7 Greville Place
London NW6 5JP

Basement Impact Assessment
Audit

For
London Borough of Camden

Project Number: 12336-63
Revision: D2

Project	7 Greville Place London, NW6 5JP
Title	Proposed Basement and Ground Floor Plans

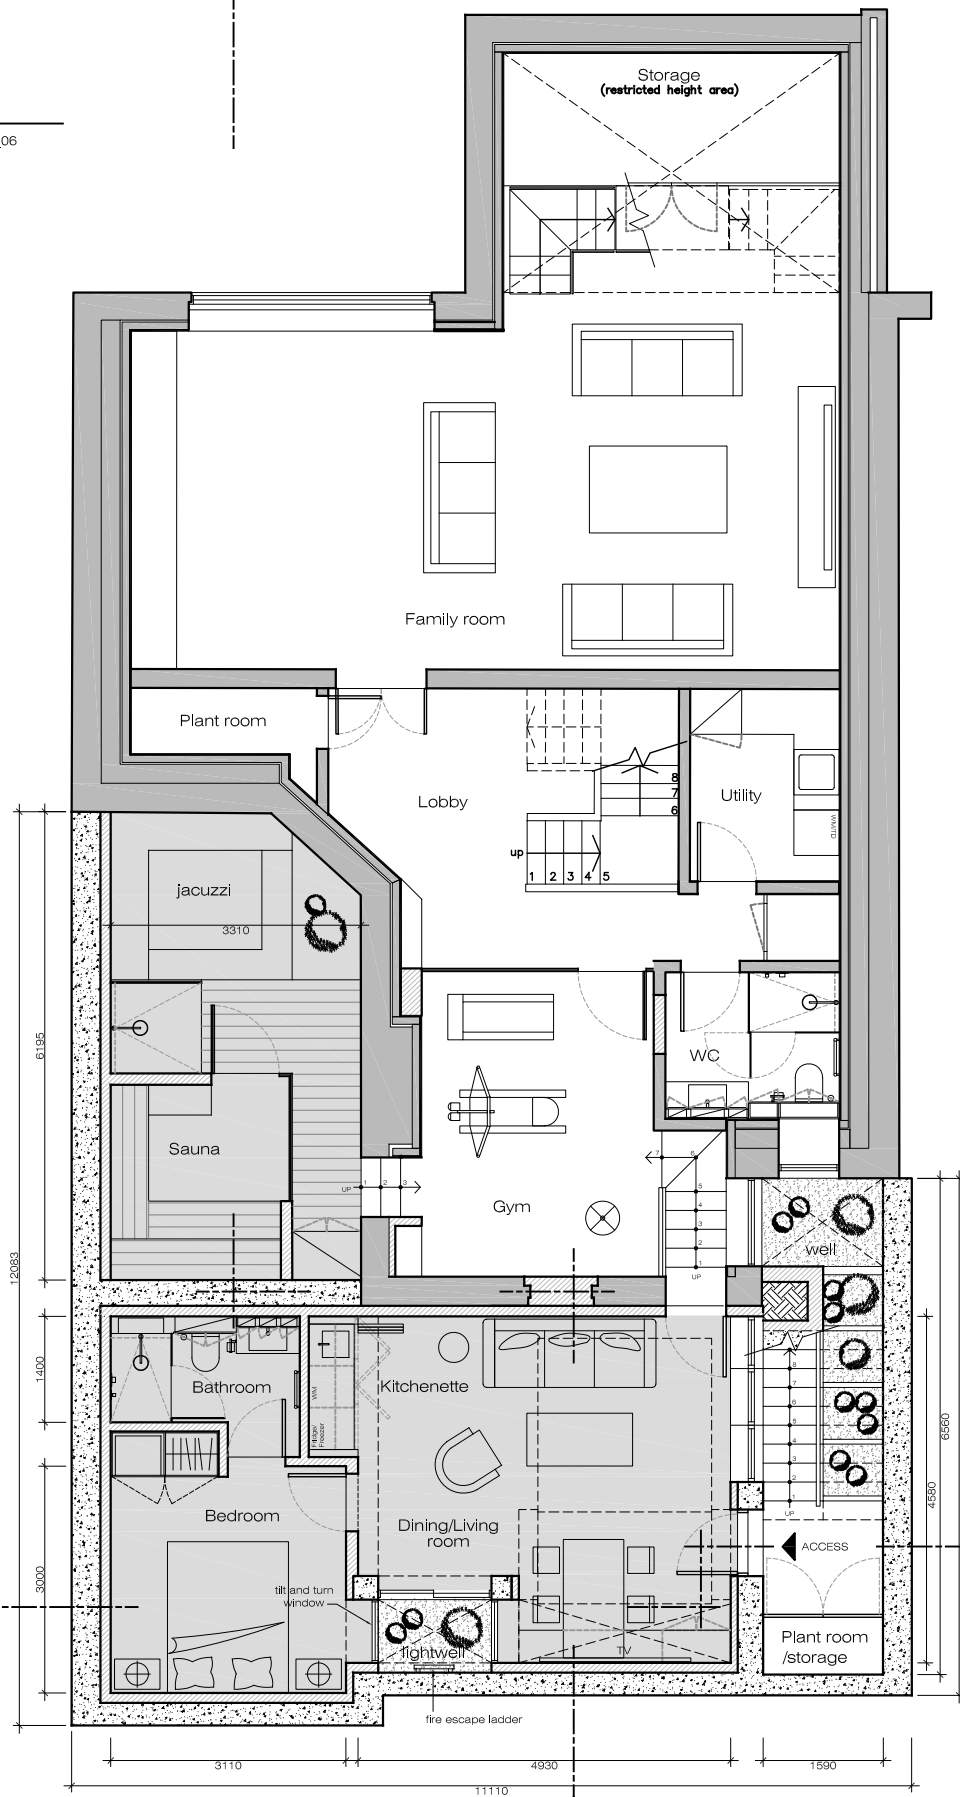
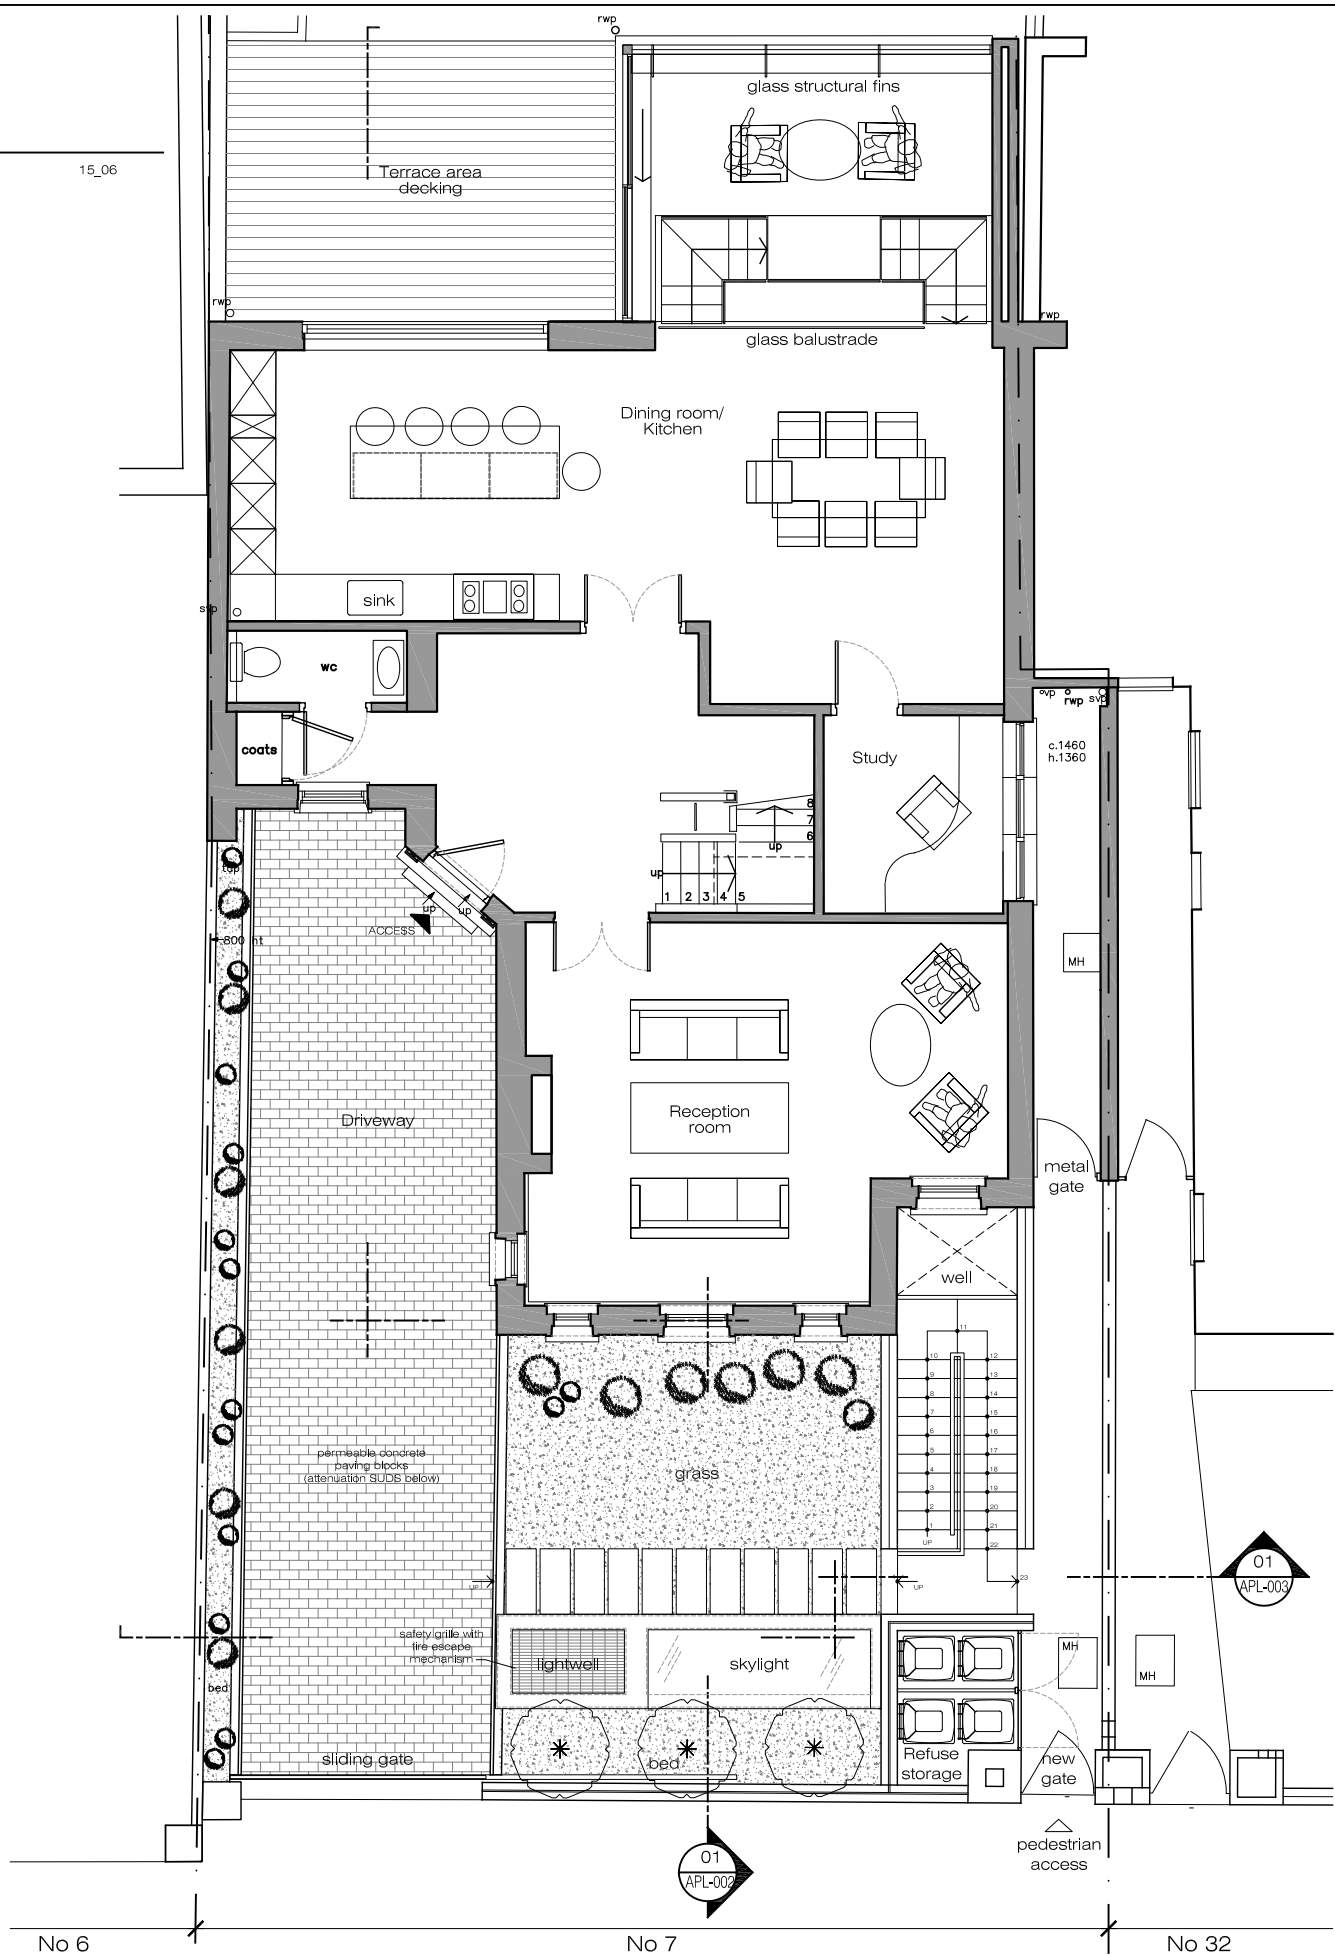
- 4.5. The Architect's drawing indicated a new wine cellar excavated beneath the existing basement. The response received to query no. 2 of the Audit query notes that the wine cellar is no longer required and therefore is omitted from the application.

Query No	Subject	Query	Status	Design team comments 22/07/16
1	BIA format	Qualifications of individuals involved not in accordance with CPG4 requirements	Open- Input of a Chartered Engineer with respect to surface flow and flooding and land stability assessments	The BIA demonstrates that there is no surface flow and flooding, from EA information and review of OS plans. Consequently there is nothing for a CEng to assess. Halsteads acting as client's engineers provide the CEng Input. Jomas provide CGeol.
2	BIA format	Proposal not sufficiently detailed (see Audit paragraphs 4.3 and 4.4)	Open-Clarification requested	<p>Please refer to attached updated Schneider Designers drawings for dimension information.</p> <p>The accompanying updated Halstead Associates drawing 16497/PL03A shows the general anticipated construction sequence. Retaining wall sections will be propped during the works until both the basement slab and ground floor slab are in place to provide a single monolithic construction.</p> <p>Wine cellar no longer required therefore omitted from application.</p>

Title
AQUAFLOW PERMEABLE PAVING LAYOUT
FOR PARKING AREA

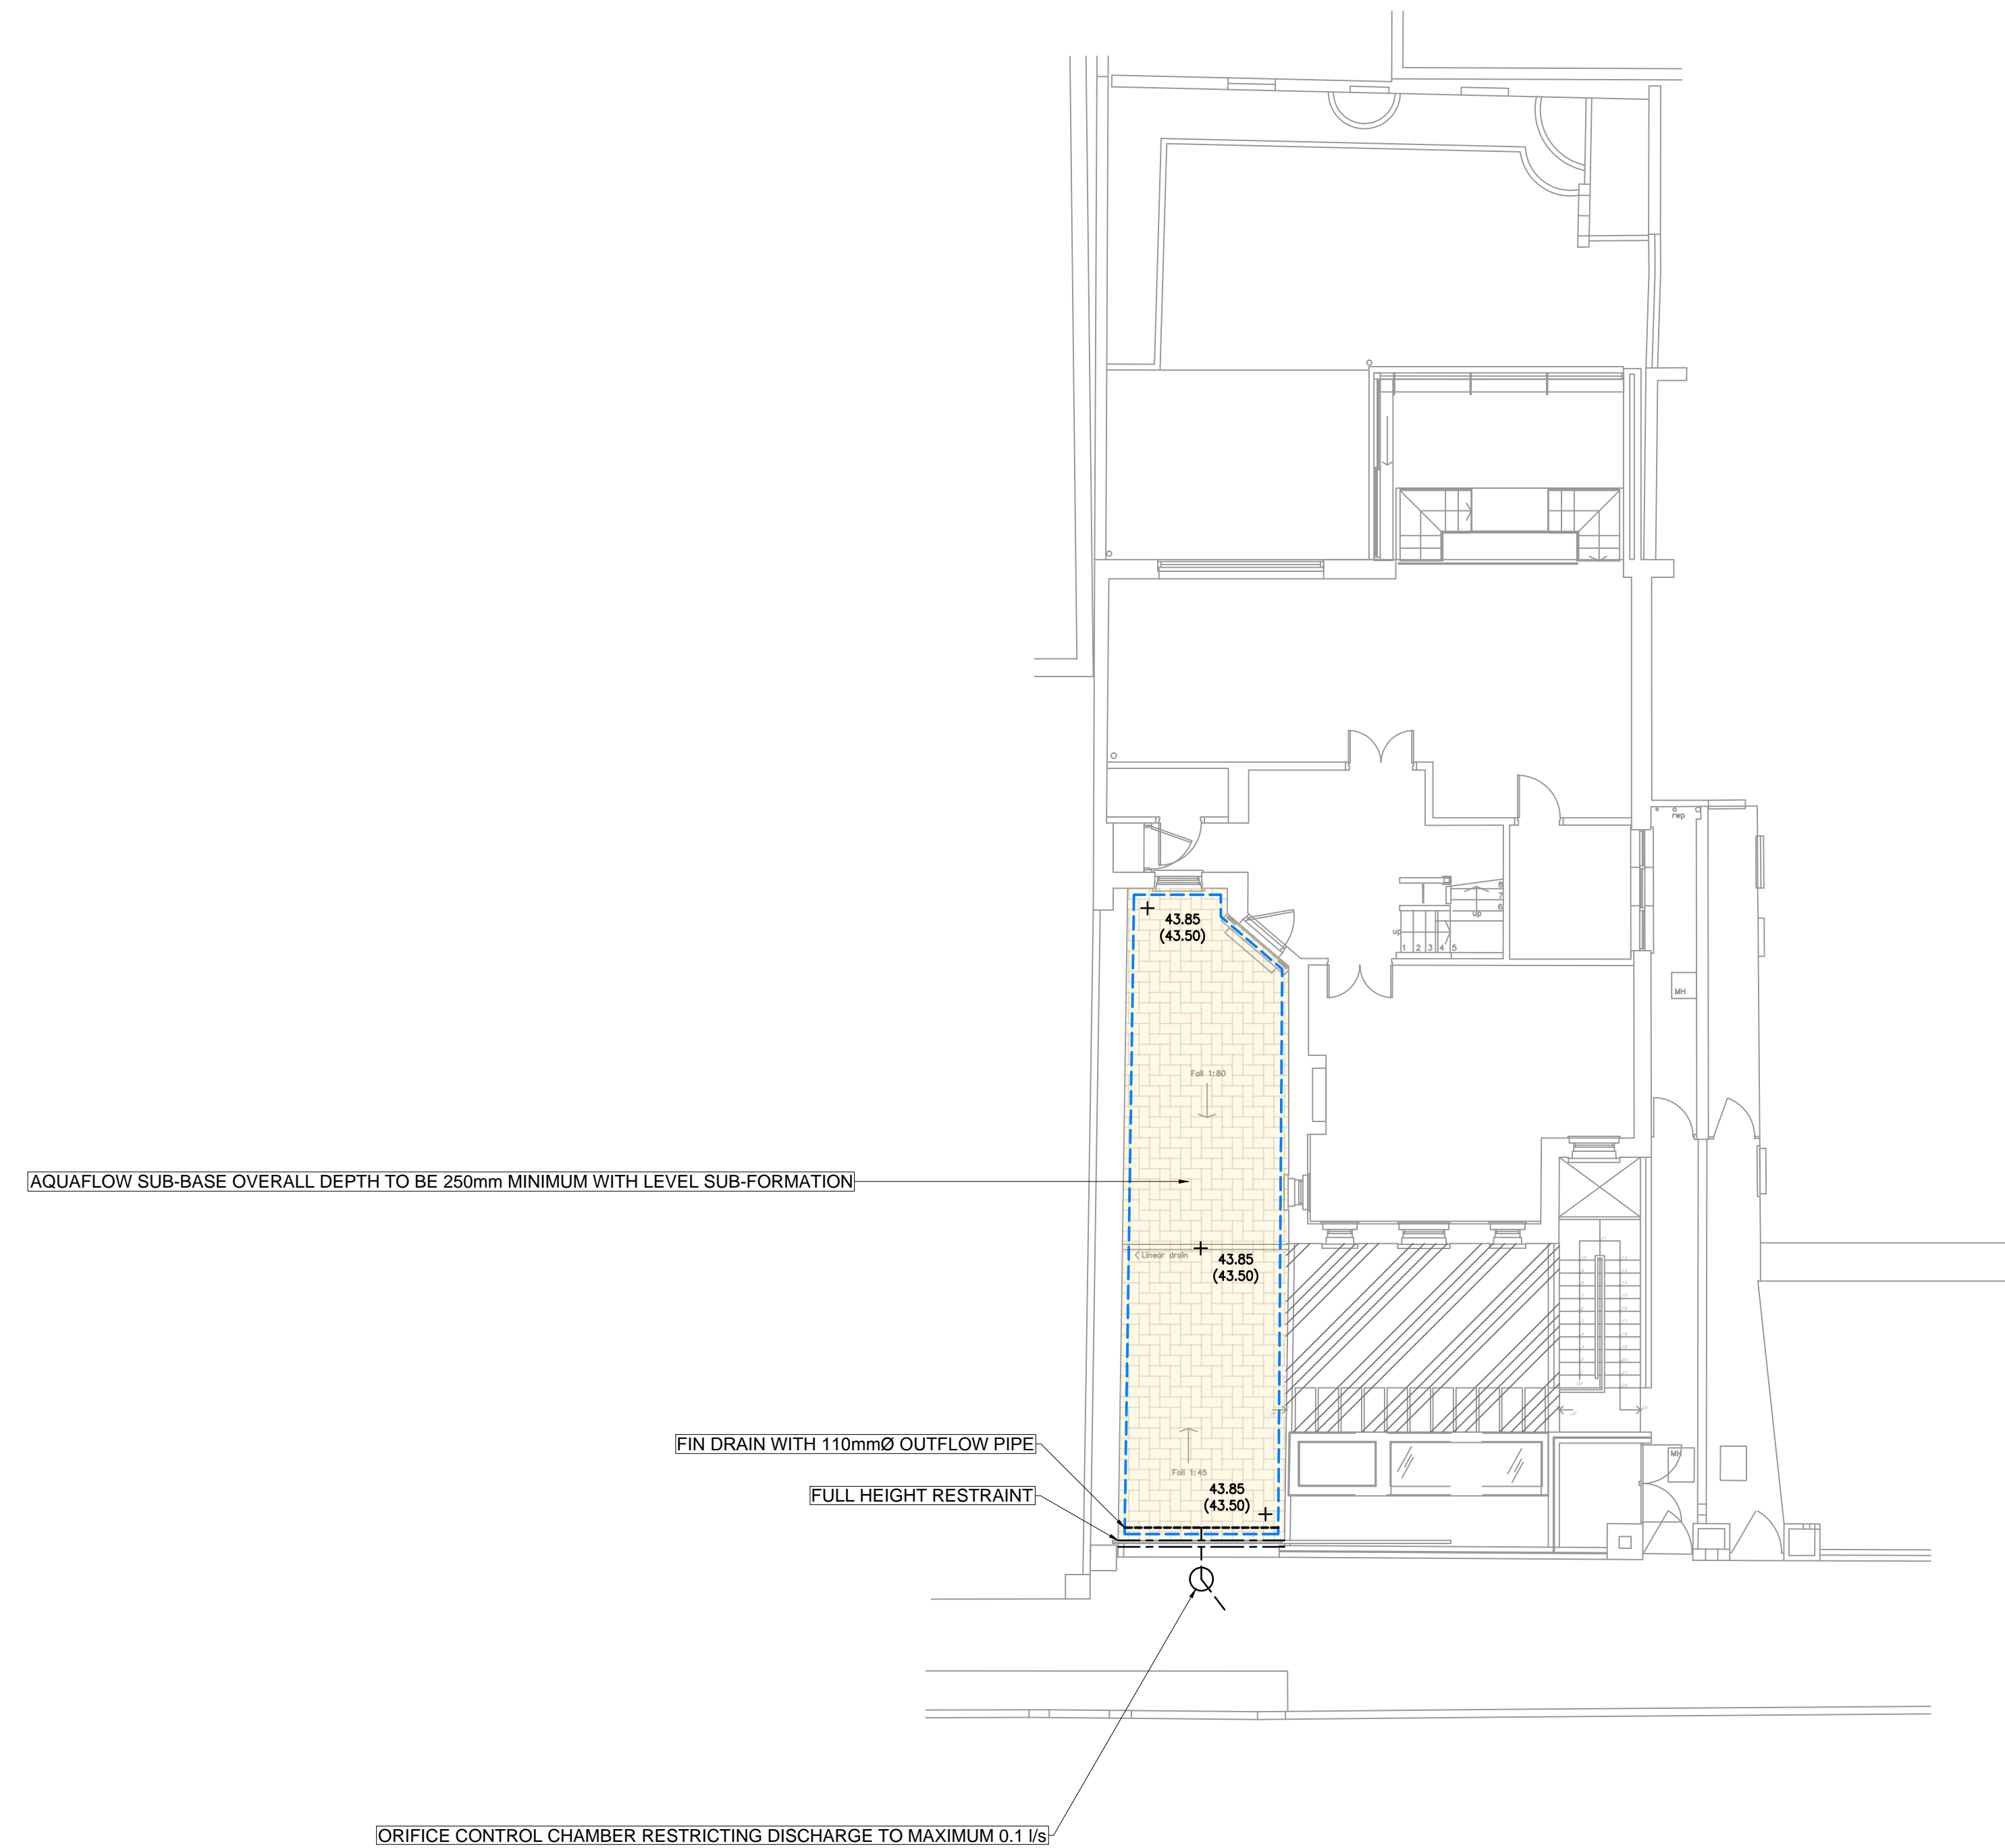
- 4.8. Clarification was requested on the proposed site drainage and whether or not surface water runoff will be infiltrated into the ground. The supplementary information has now been provided.

3	BIA format	Works programme not provided	Open- Outline programme to be provided	Please refer to Schneider Designers Outline Programme attached.
4	Hydrology	Clarification requested on the proposed site drainage (see Audit paragraph 4.8)	Open-Clarification requested	<p>Jomas are not undertaking the drainage assessments. As far as possible understand from the survey carried out to the property the sewer network runs along the side passage.</p> <p>In response to guidance CPG3 and policy DP23 it is proposed a dual system of SUDS for the driveway and a French Drain System for the garden and remaining soil areas, connecting to the existing network.</p> <p>Please refer to attached Schneider Designers new drawings APL-303 and APL-304 together with SUDS consultant information FSC3649 - Design Calculations; FSC3649 - D1 and FSC3649 - D100. All to be consider provisional.</p>
